Exhibit D

RE: 25475 Hatton Proposed ADU and Redwoods

Subject: ADU Tree Impact Assessment for 25745 Hatton Road, Carmel

Re: PLN240104 – 25745 Hatton Rd., Carmel (Kitayama Nagafuji)
Our File: 60107.70158

S. sempervirens with 3 test sites to determine if any roots are impacted by development.

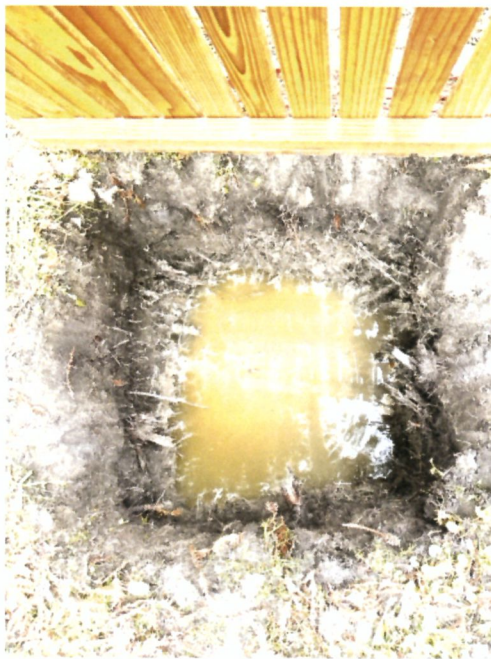
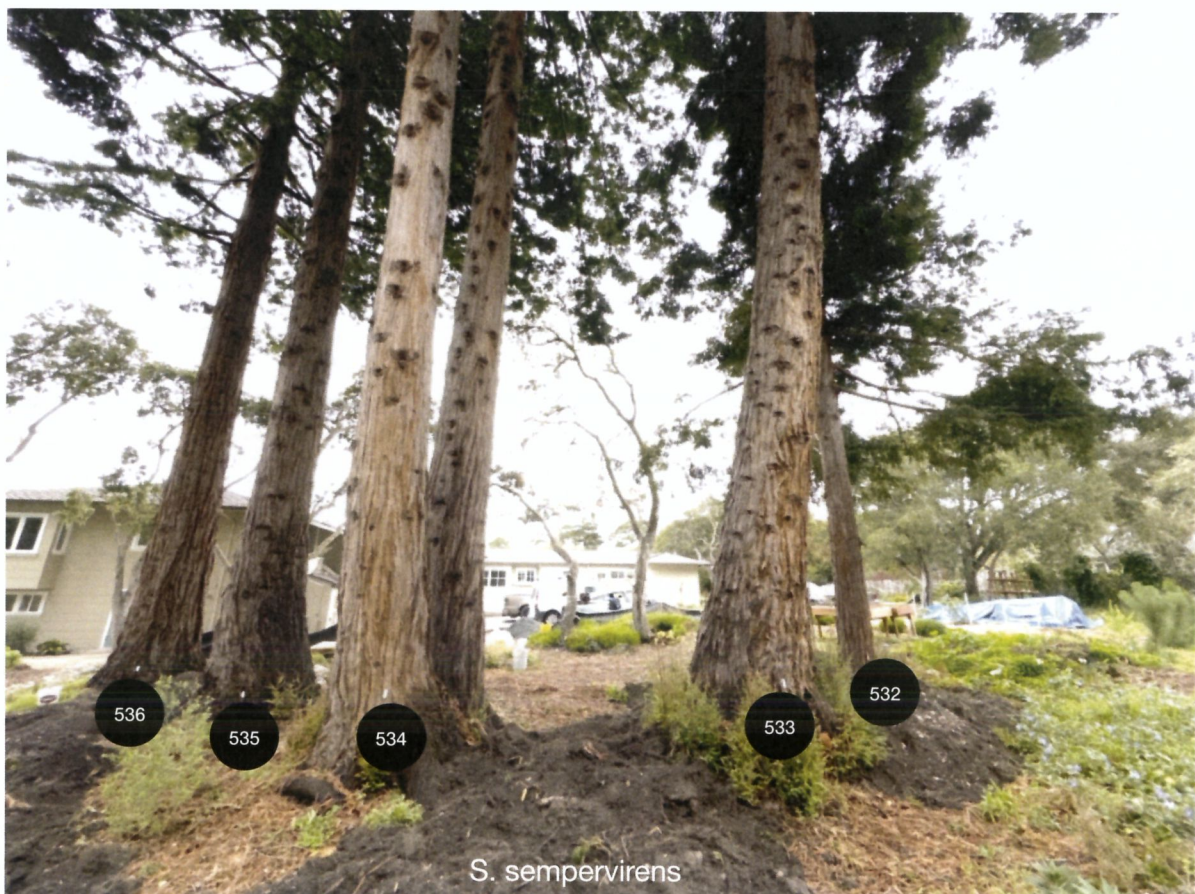
Test site 1 has minimal $\leq 1"$ diameter non-woody roots and no primary roots. Impacts are none.

Test site 2 has minimal $\leq 1"$ diameter non-woody roots and no primary roots. Impacts are none.

Test site 3 has minimal $\leq 1"$ diameter non-woody roots and no primary roots. Impacts are none.

Figure No. 2: Showing critical root zone of trees numbered 1, 2 and 3 in close proximity to the proposed ADU foundation area.

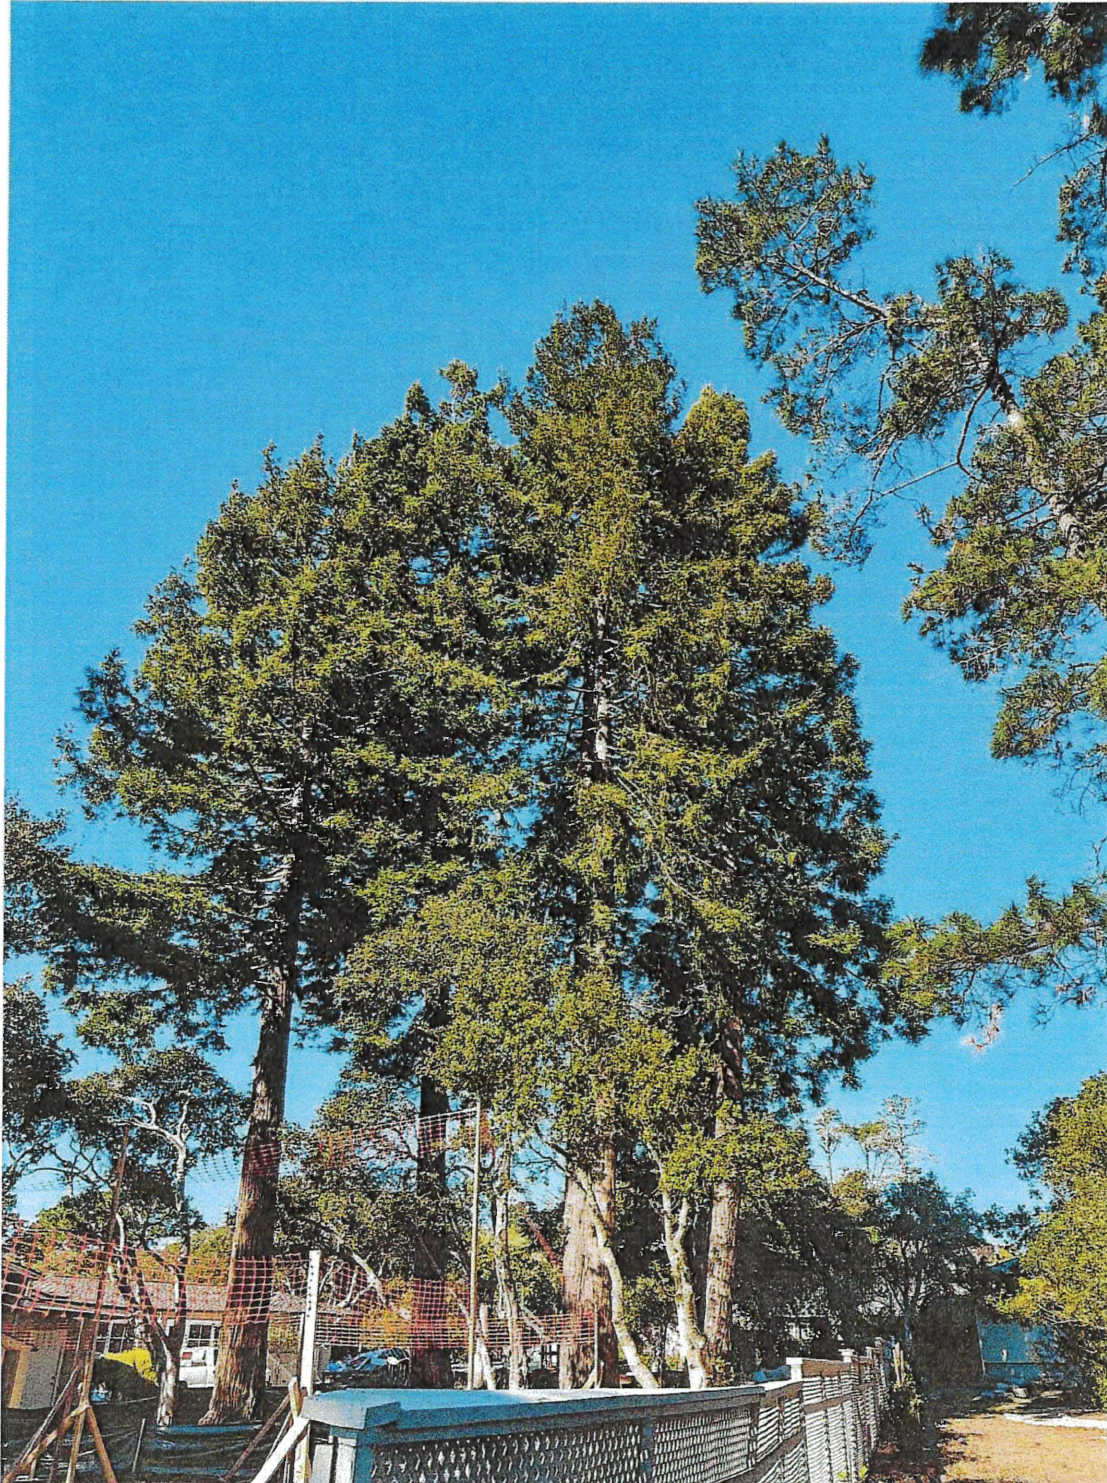
“Installation of a concrete foundation which outlines the footprint of the ADU will require severance of the roots of those trees in that area of the grove rooting bed, and will prohibit or greatly inhibit future tree rooting in the footprint area. This can effect the vertical stability of those trees as they grow in height.”

Figure No. 3: Site of southwest ADU reposition proposal, requiring removal of small and large oak saplings.

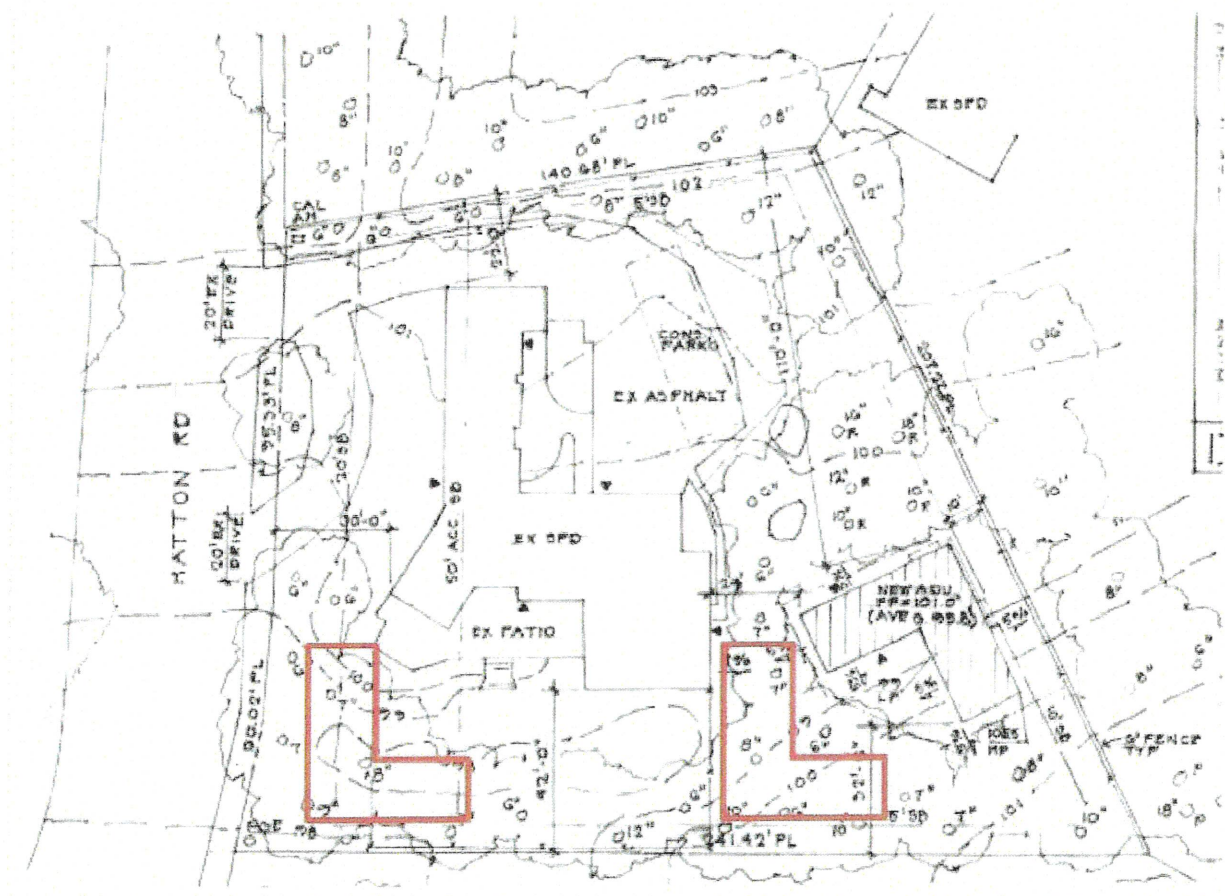
Figure No. 2: Site of southeast ADU reposition proposal, requiring removal of the senescent pine tree and small oak saplings. Notice the numerous pine saplings.
